# **Official Transcript of Proceedings**

## **NUCLEAR REGULATORY COMMISSION**

Title: Advisory Committee on Reactor Safeguards  
Open Session

Date: Thursday, March 5, 2020

# Steam Generator Inlet Flow Restrictor

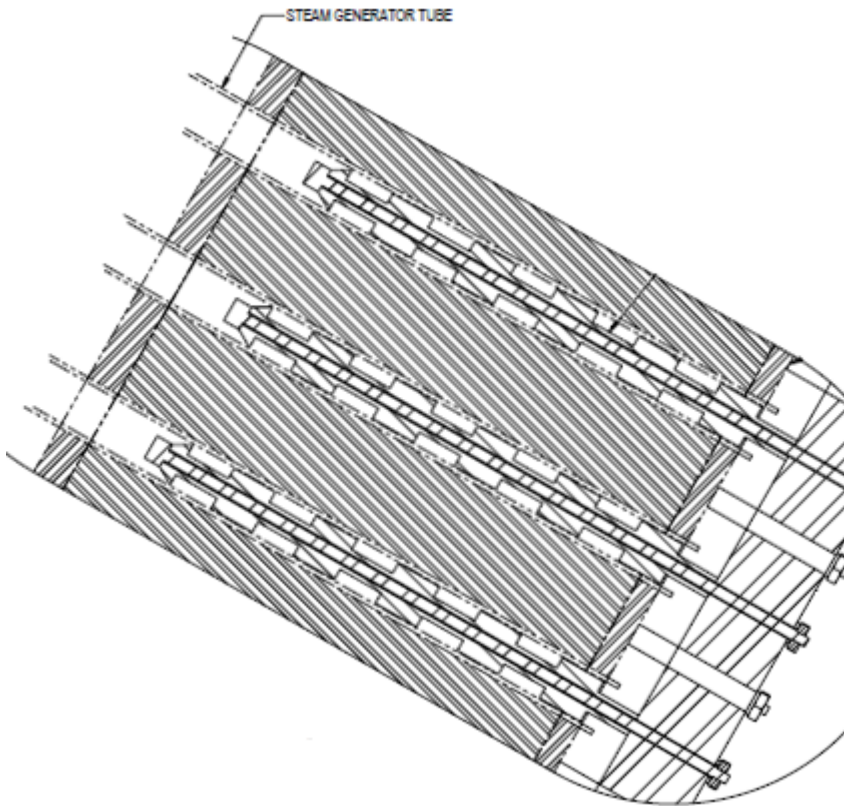
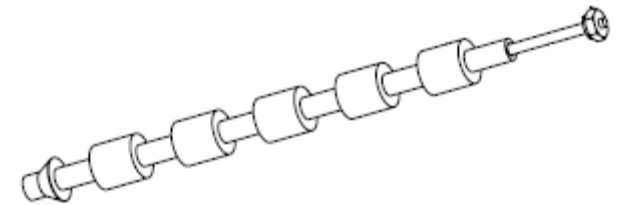
12 But what I did want to mention here with  
13 the five, with the set of five expansions you'll  
14 notice that the IFR is contained within the actual  
15 tube sheet.

19 MEMBER MARCH-LEUBA: What is the tube  
20 sheet?

3 CHAIRMAN SUNSERI: So, when you said the  
4 tube straight piece is 30 inches or so is that  
5 including the length through the tube sheet or after  
6 it passes through the tube sheet?

8 MR. SPENCER: So, in this drawing here it  
9 would be welded in between the IFR mounting plate.  
10 And you'll see there's clouding on that second side.  
11 That's to allow a similar metal weld.

2                   MEMBER BALLINGER: What is the orientation  
3       of the flow restrictor, is the left-hand end the  
4       furthest end of the tube sheet?

2 MEMBER BALLINGER: Now I have one more  
3 question. Is there any thought to having an ejection  
4 collar on one of those things?

7 MR. SPENCER: The straight section from  
8 the feedwater transition plenum is probably on the  
9 range from 20 to maybe 35 inches overall. And then  
10 that does include the length of tube which is, which  
11 passes through the tube sheet and is welded on the  
12 secondary face of the tube sheet.

13 I think I can say that it's probably not  
14 proprietary to say that. That's on the order of six  
15 inches is the thickness of the tube sheet.

5                   MR. SPENCER: The furthest end of the tube  
6       sheet is the tip, yes.

22 So, if we change the operation that  
23 affects the design and that allows us to reexamine the  
24 design. But the current design that we're presenting  
25 today doesn't include that feature.

# SG Inlet Flow Restrictor

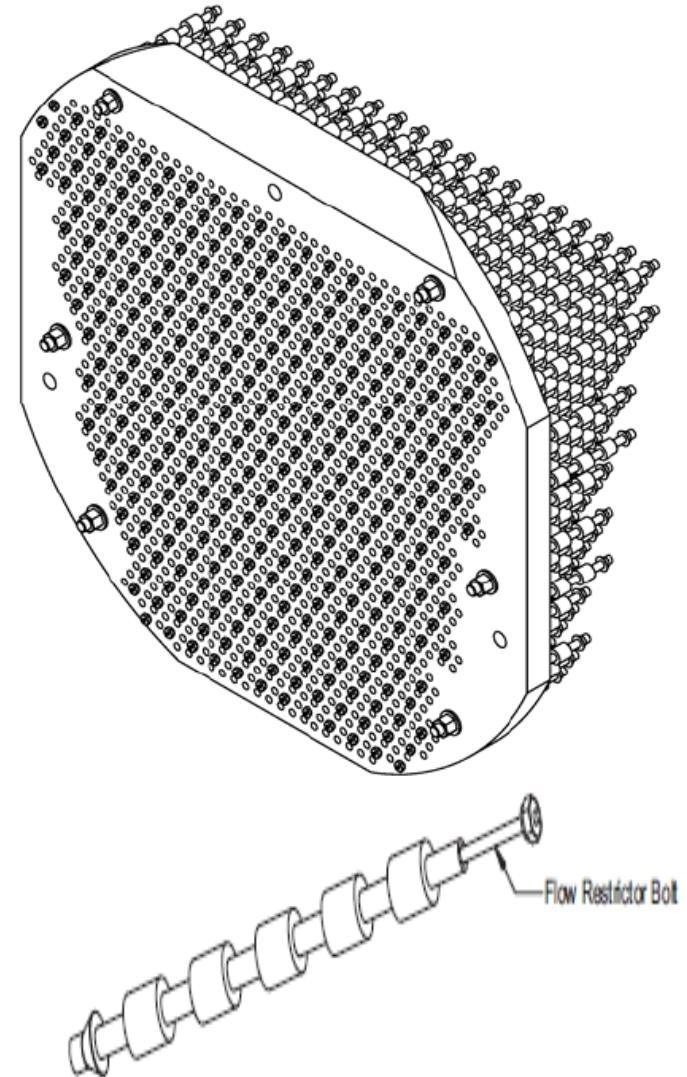
14          MEMBER BLEY: Excuse me. Two related  
15          questions. When you say they're less, the flow  
16          restrictors are less stable under reverse flow  
17          conditions, what do you mean by that?

18          And my second question is I'm envisioning  
19          this thing maybe going back and forth a little bit.  
20          And can these screws back out? I've seen screws back  
21          out in vibrating situations.

- SG Inlet Flow Restrictor (IFR) designed to provide necessary pressure drop to limit DWO in the SG tubes.
- Staff evaluated leakage flow instability (LFI) between IFRs and SG tubes during forward flow test (separate from TF-2) and did not identify any concerns.
- However, testing did include DWO conditions.
- NuScale has not validated the final IFR design.
